Atlantic Crossing

CLASS II MODIFICATION 2019 - 8.2.2019

CLASS II MODIFICATION SUPPLEMENT 10.25.2019

PLAZA SUPPLEMENTAL EXHIBITS

1/4" = 1'-0"

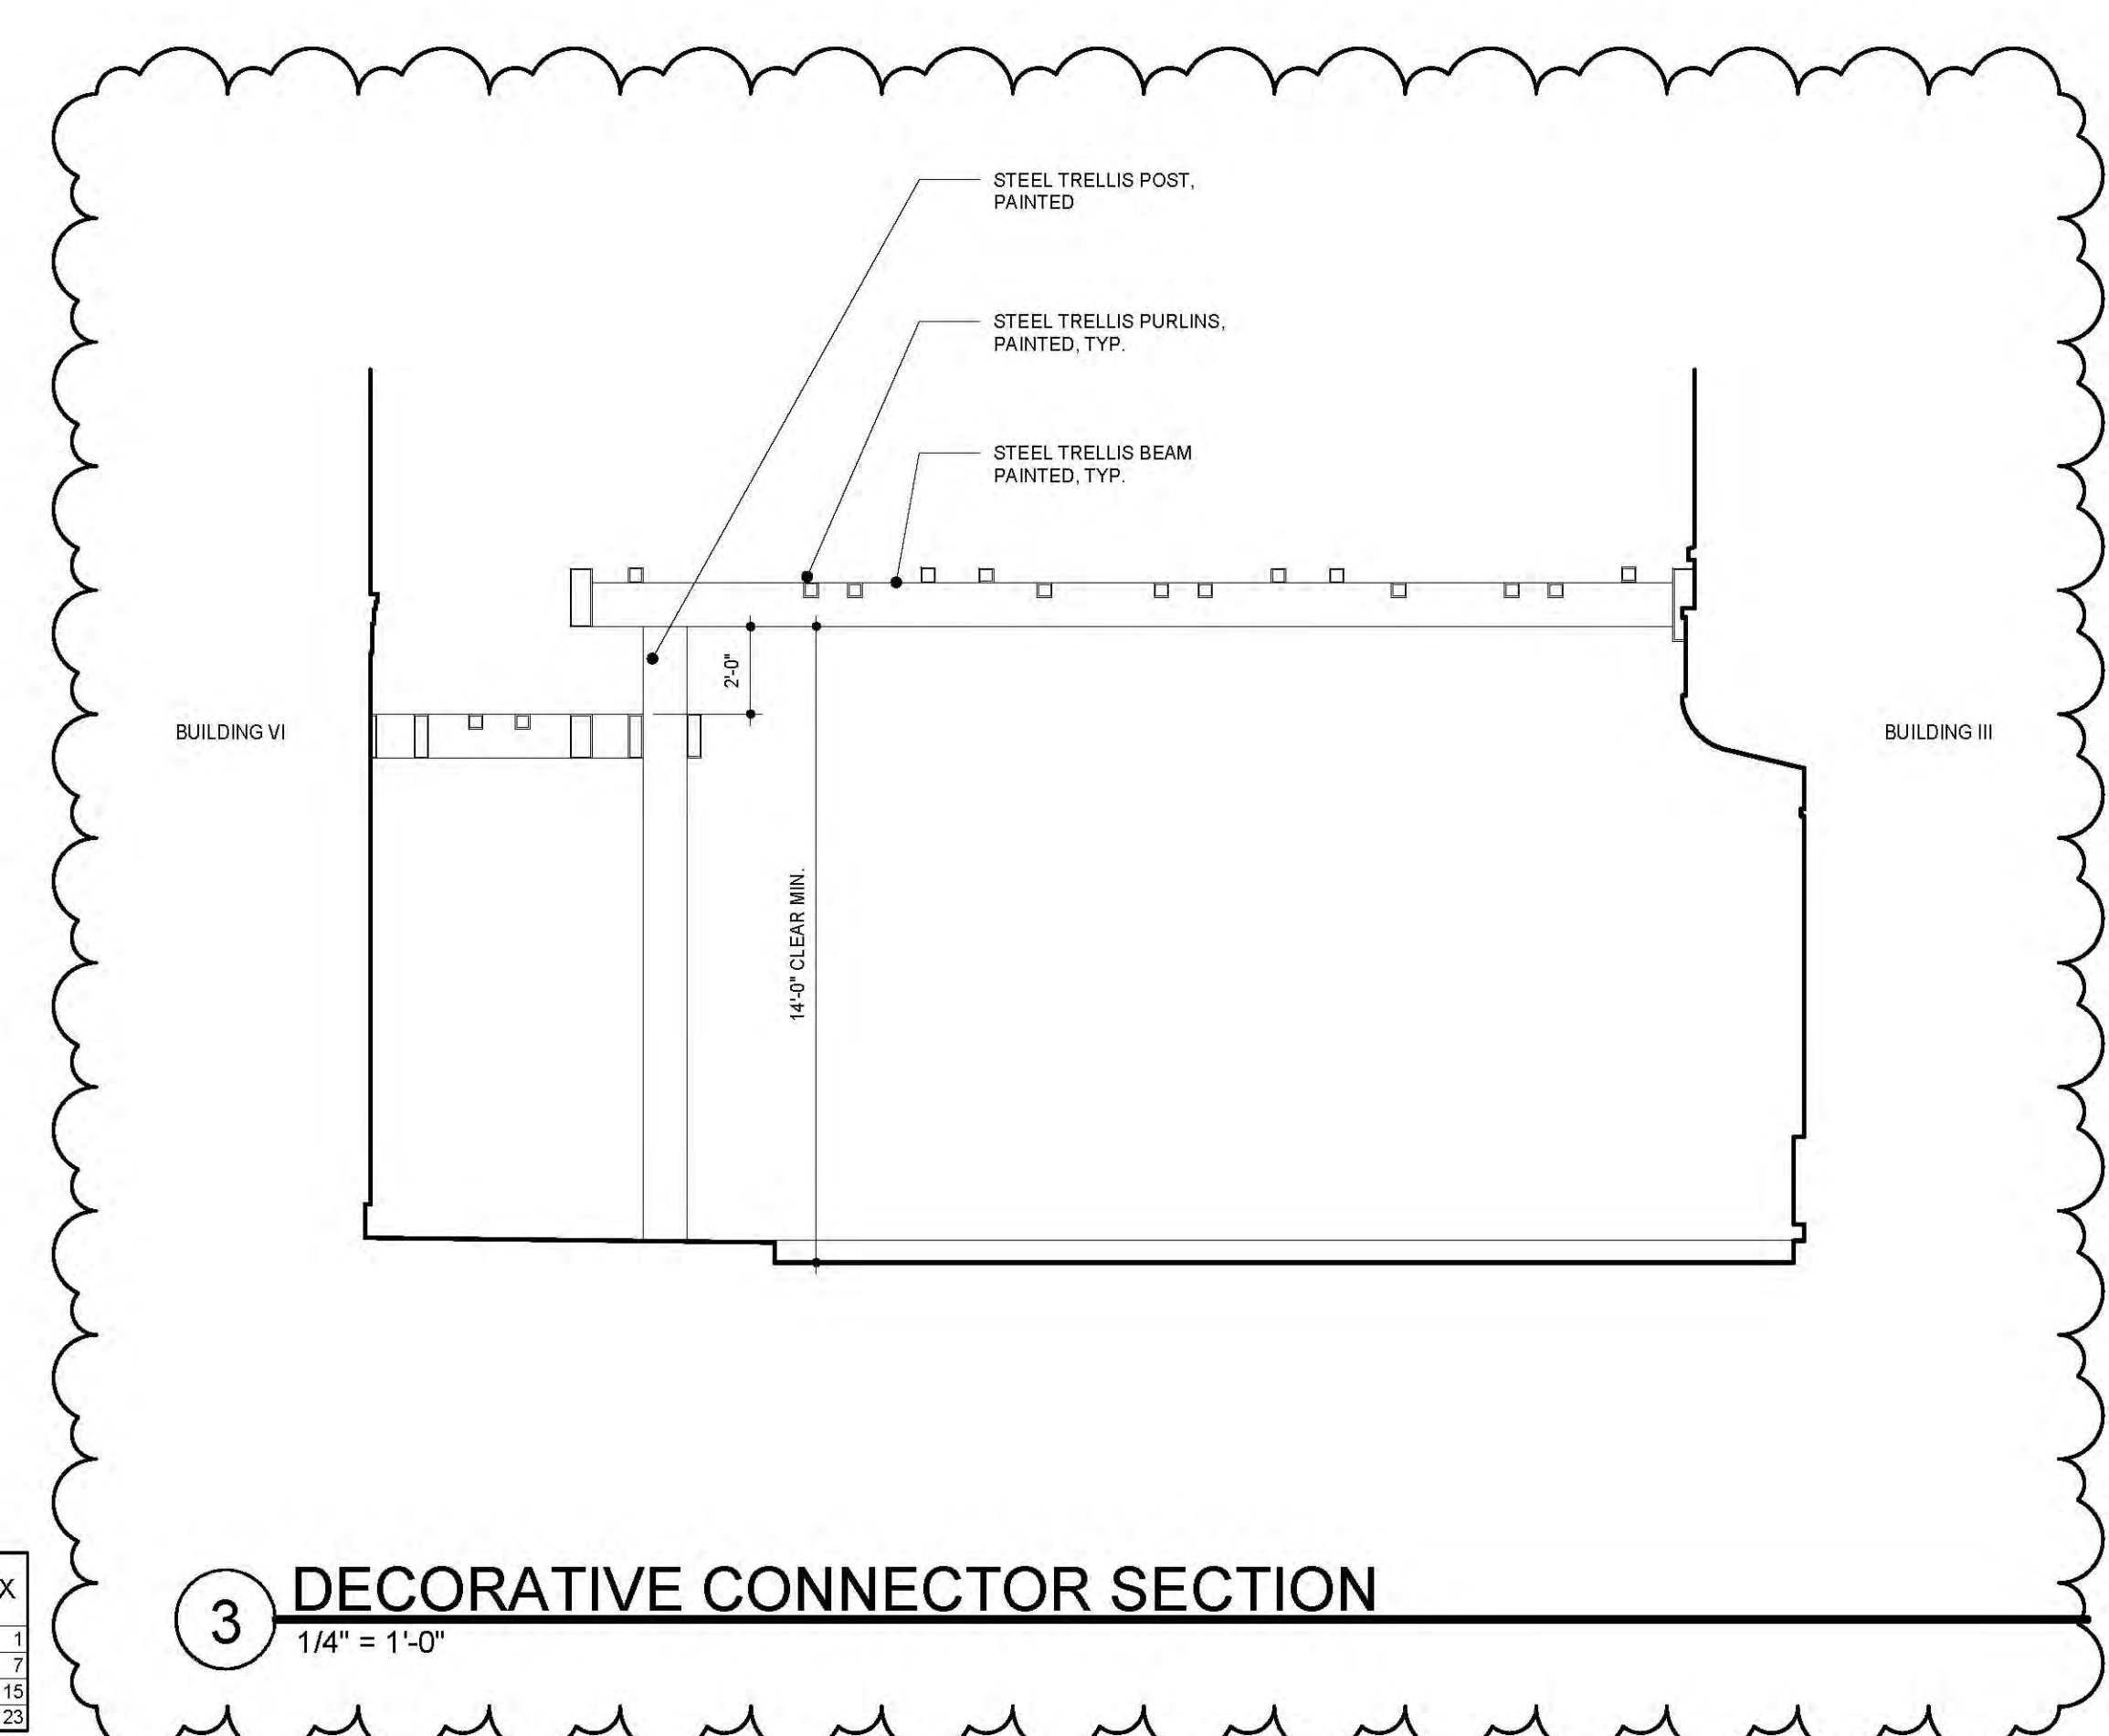
RESPONSE TO 2.12.14 STAFF COMMENTS

- BUILDING III NORTHWEST FOOTPRINT ADJUSTED DUE TO ADDITION OF RAMP AT NE 8TH AVENUE
- ADJUSTED EASEMENT LINE ON WEST SIDE OF N.E. 7TH AVE.
- FLOOR PLANS REFLECT RESIDENTIAL UNIT COUNTS.

RESPONSE TO 2.6.15 STAFF COMMENTS

- REFORMATTED UNIT MATRIX
- SETTLEMENT MODIFICATION 4.21.2017
- ADD ARCADE TO THE NORTH AND REDUCED SQUARE FOOTAGE ACCORDINGLY
- DELETED CANTILEVER ON NORTH AT SECOND FLOOR

- REVISE DETAIL AT ARCADE
- ADD TRELLIS BETWEEN III & VI-S

BLDG III ELEVATIONS

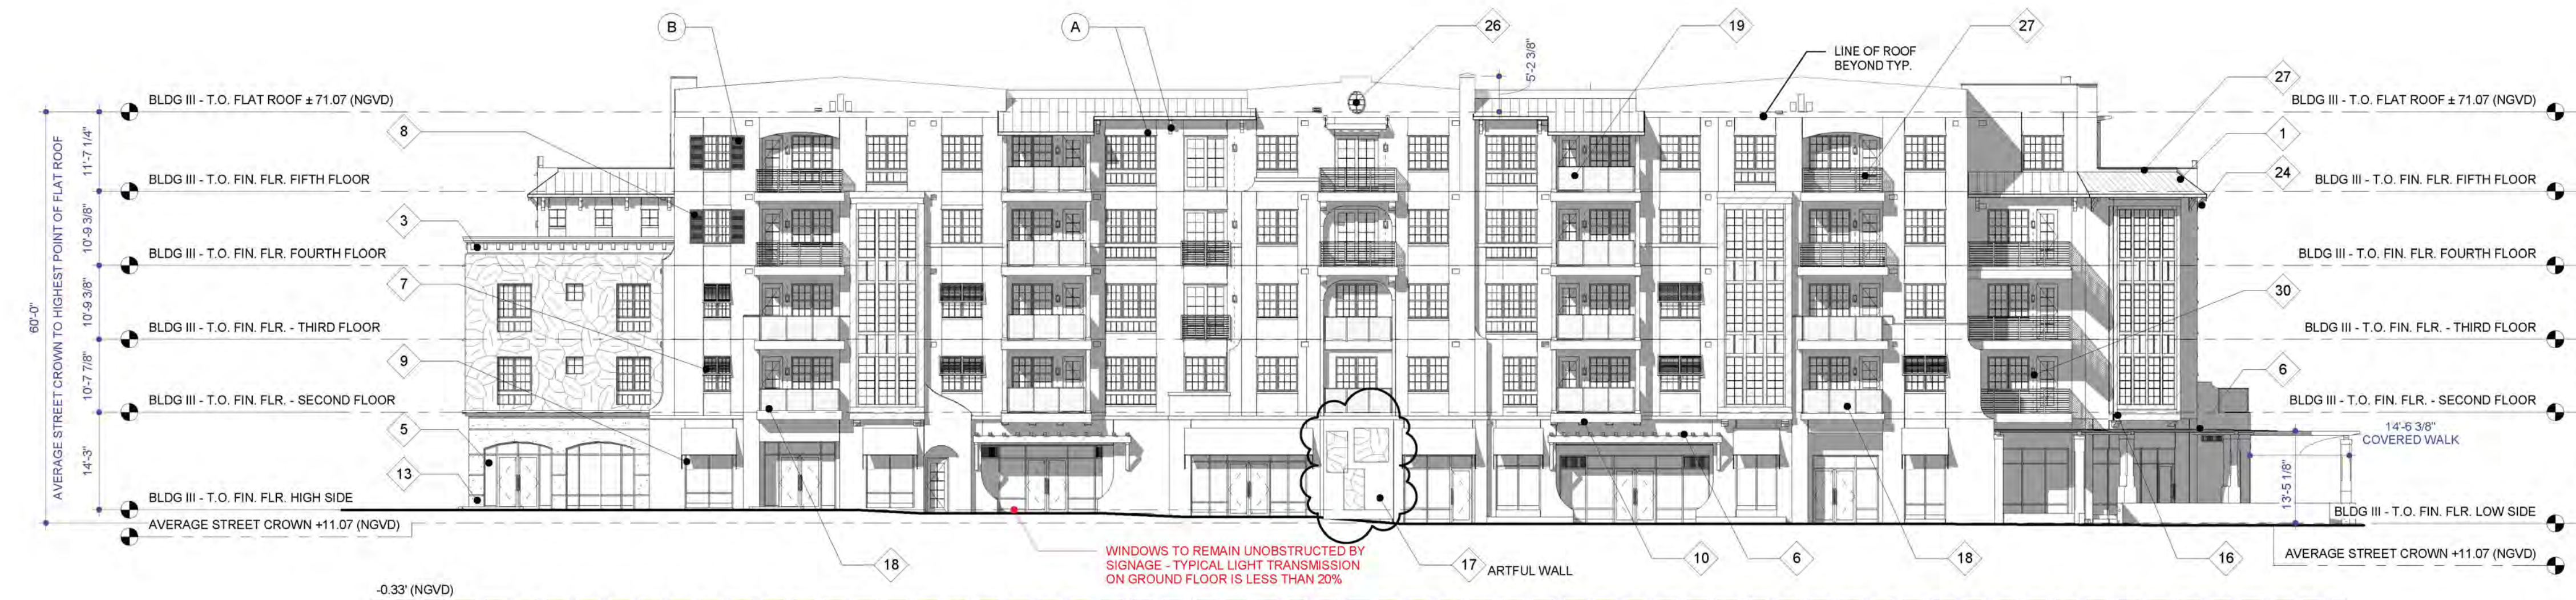
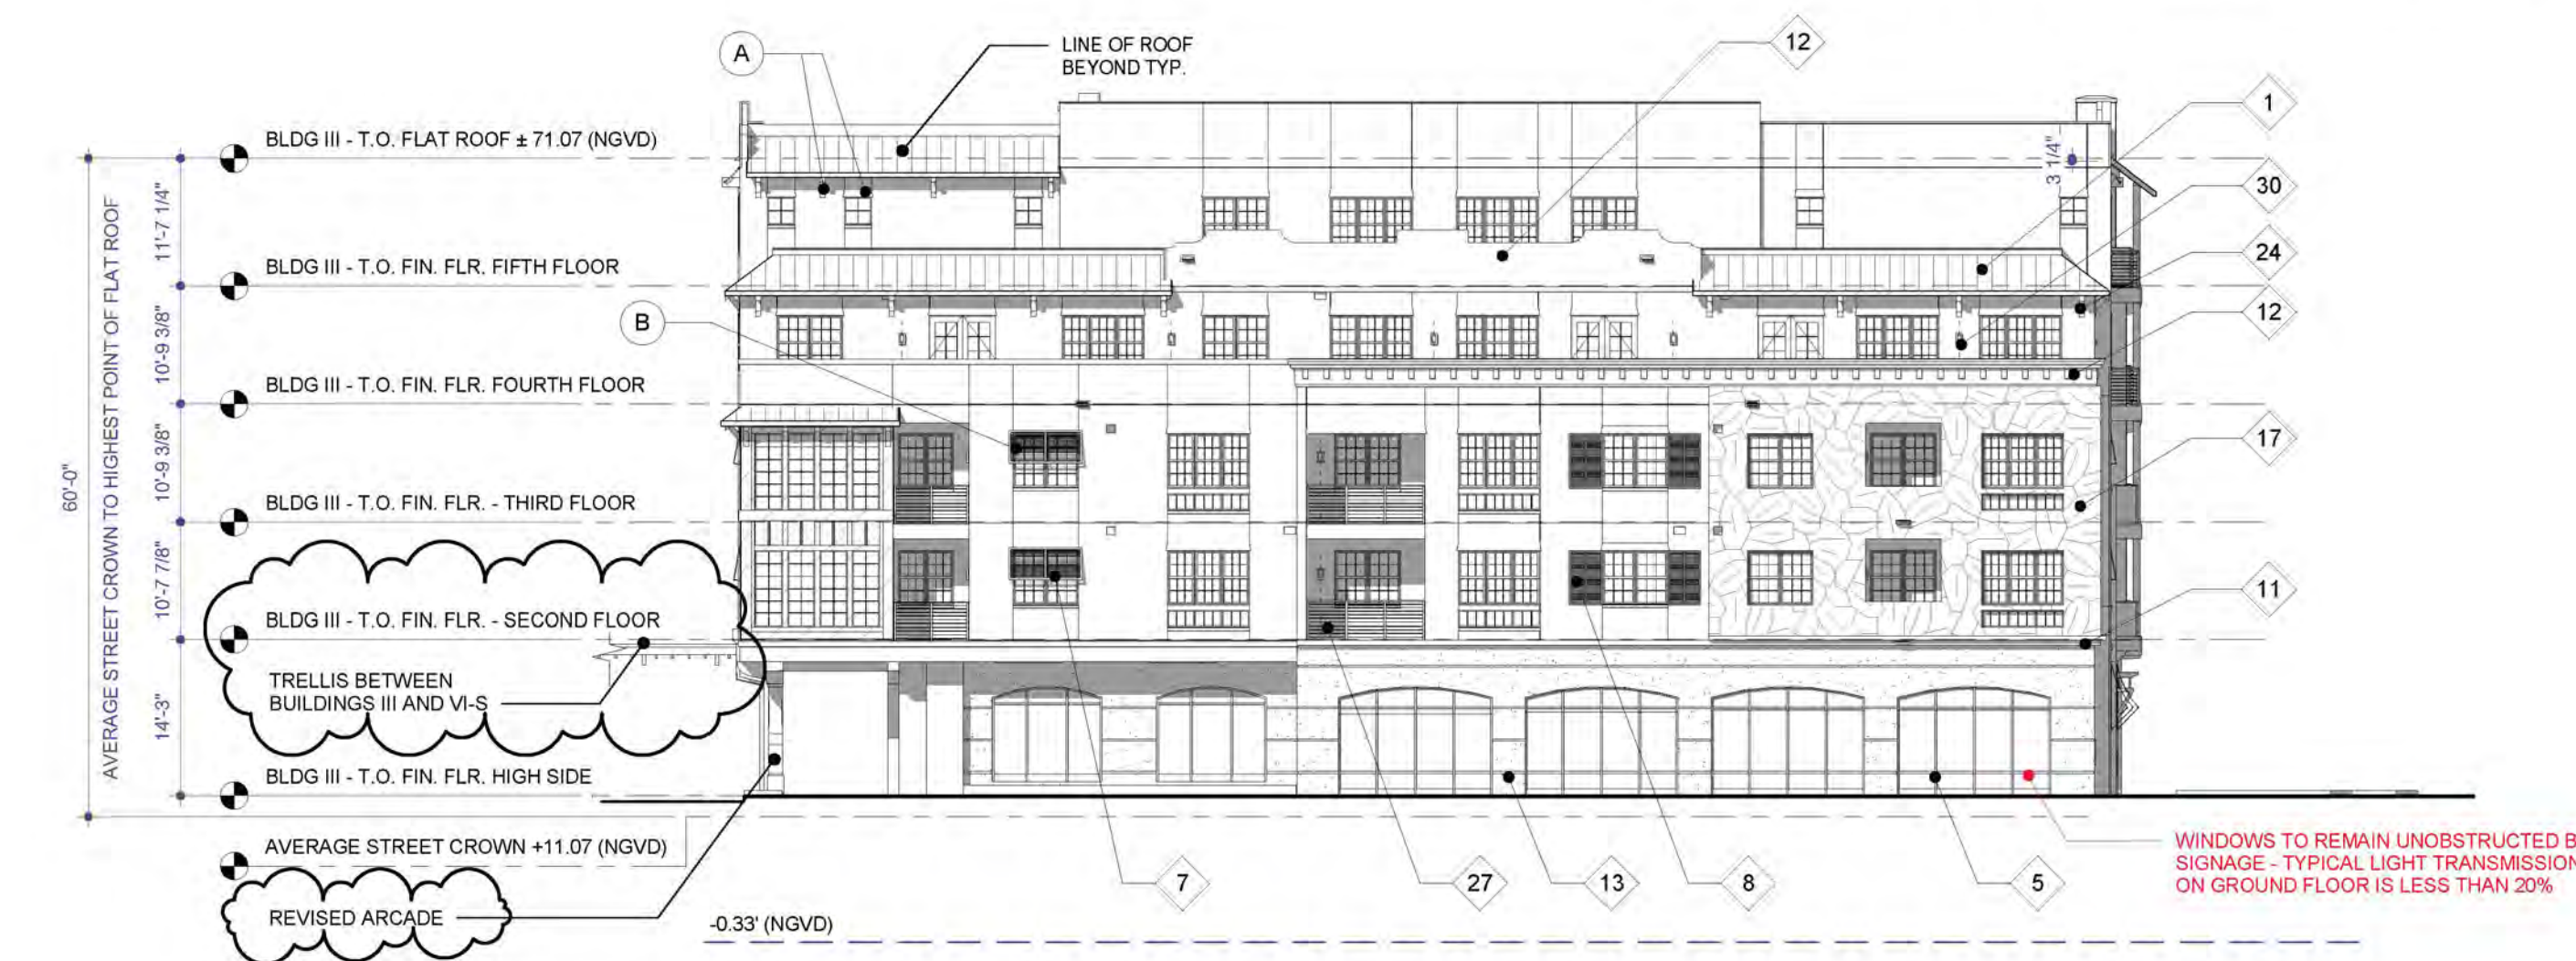
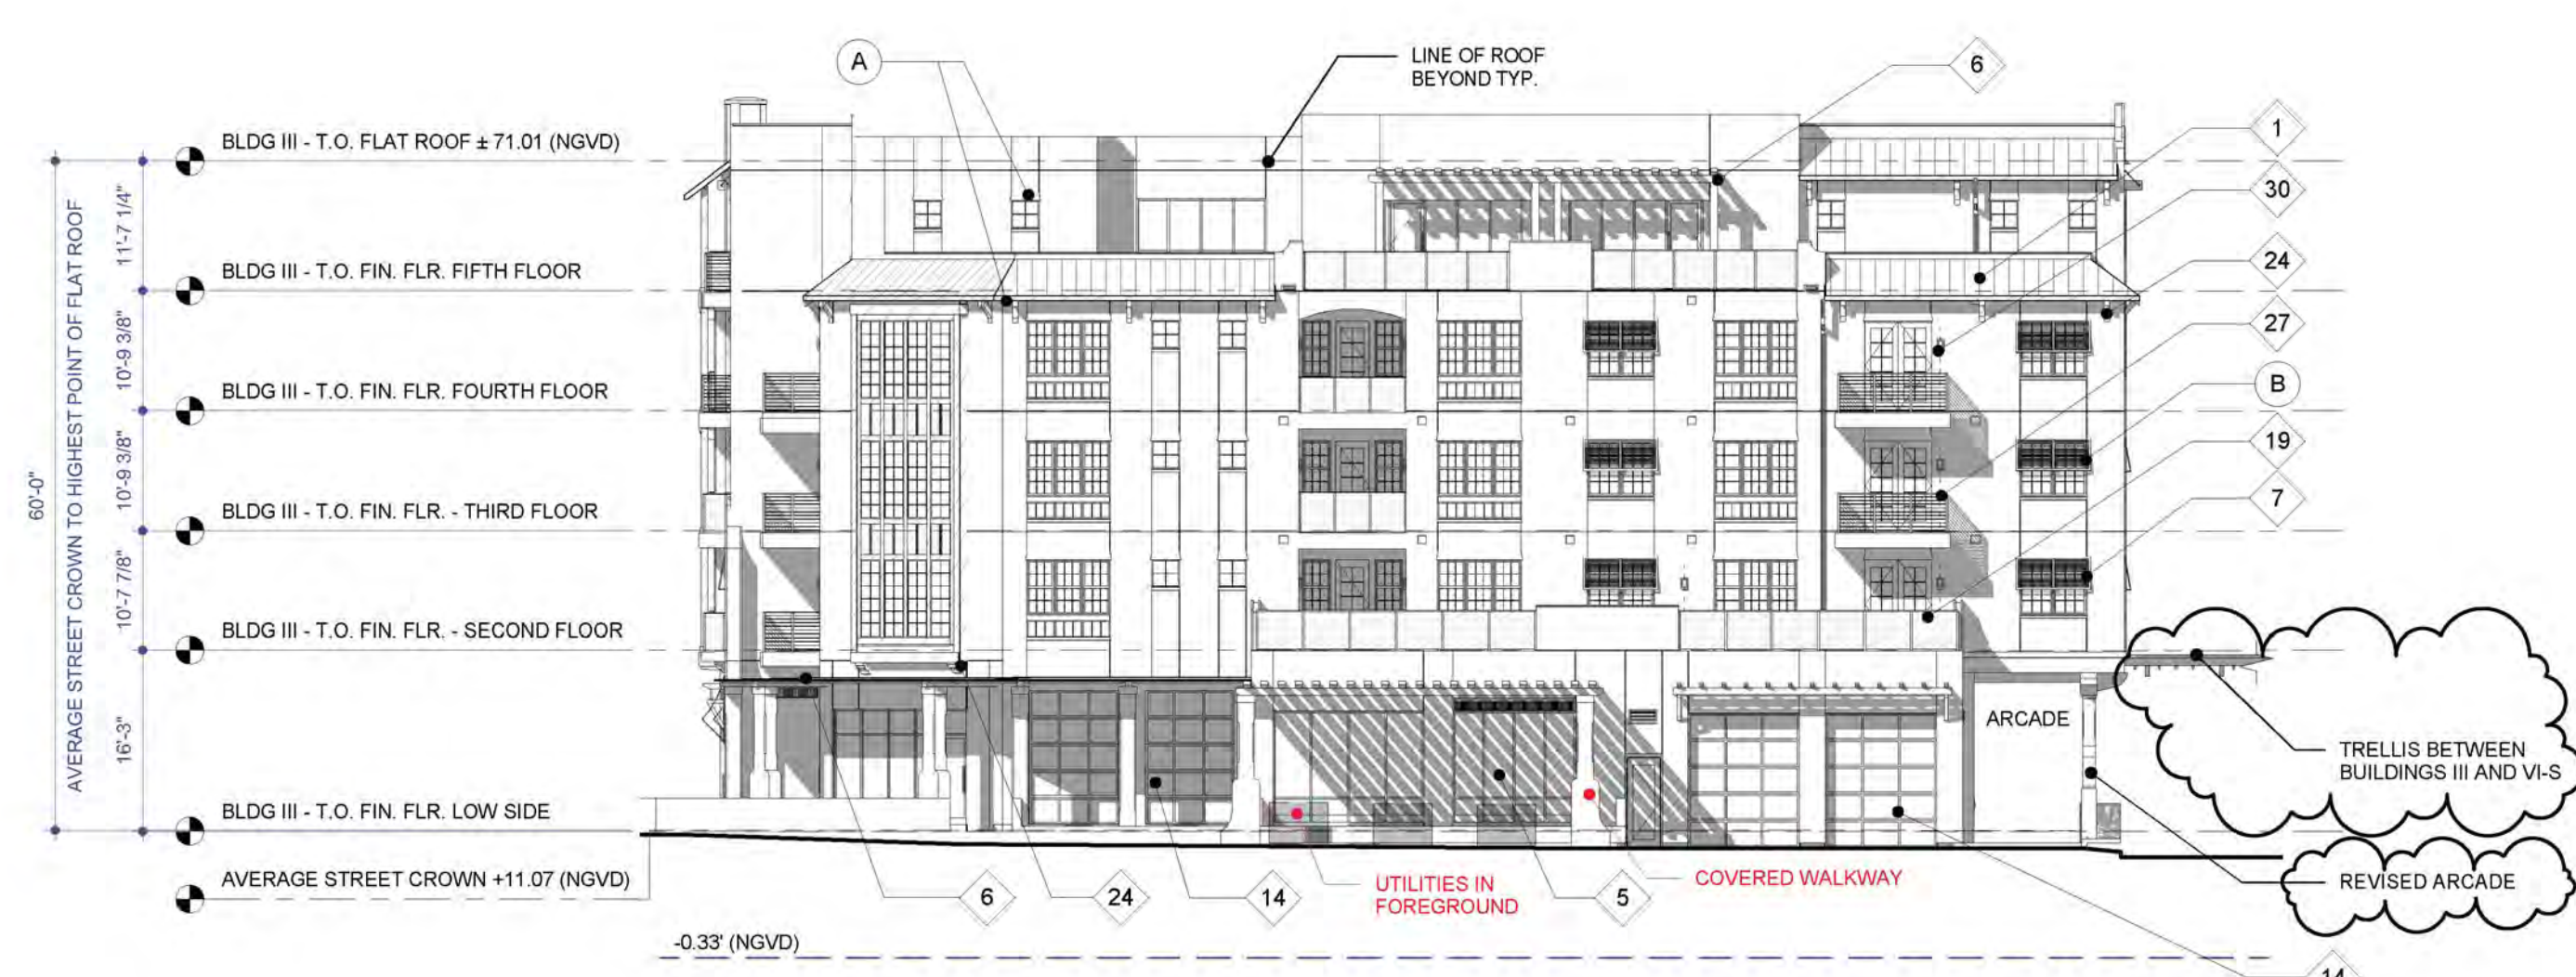
RESPONSE TO 2.12.14 STAFF COMMENTS
BUILDING III NORTHWEST FOOTPRINT ADJUSTED DUE TO ADDITION OF RAMP AT NE 6TH AVENUE
WINDOWS OF THE BUSINESSES AND OFFICES REMAIN UNOBSTRUCTED BY SIGNAGE
LIGHT TRANSMISSION FOR GROUND FLOOR GLASS AREA TO BE NO GREATER THAN 20%
KNOX BOXES TO BE PROVIDED AT ROLL DOWN GATES
GREEN WALL IS CONSIDERED A TRELLIS WHICH SHALL BE ALLOWED TO ENDOACH INTO SETBACK ALONG FEDERAL HIGHWAY
ADDED INGRESS/EGRESS RAMP AT NE 6TH AVE

SETTLEMENT MODIFICATION 4.21.2017
ADD ARCADE ALONG THE NORTH ELEVATION
ADJUST POSITION OF LOADING AREA
ADJUST EAST AND WEST ELEVATIONS DUE TO ADDITION OF ARCADE

ARCHITECTURAL ELEVATION REVISIONS 7.19.2018
GENERALLY REVISE ELEVATIONS TO BE MORE CONSISTENT WITH ANGLO CARIBBEAN, INCLUDING:
SCULPTED FORMS AT ARCADE AND AT FEATURE ELEMENTS OF THE BUILDING
RE-SCALE WINDOWS AT CORNERS
WOOD DETAILING AS ACCENT AT VERTICAL FORMS
ENTRANCE DETAIL AT BUILDING CAP
RE-DETAIL ARCADE AND LOW ROOF FORMS

CLASS II MODIFICATION 2019 8.2.2019
REVISE DETAIL AT ARCADE
ADD TRELLIS BETWEEN III & VI-S
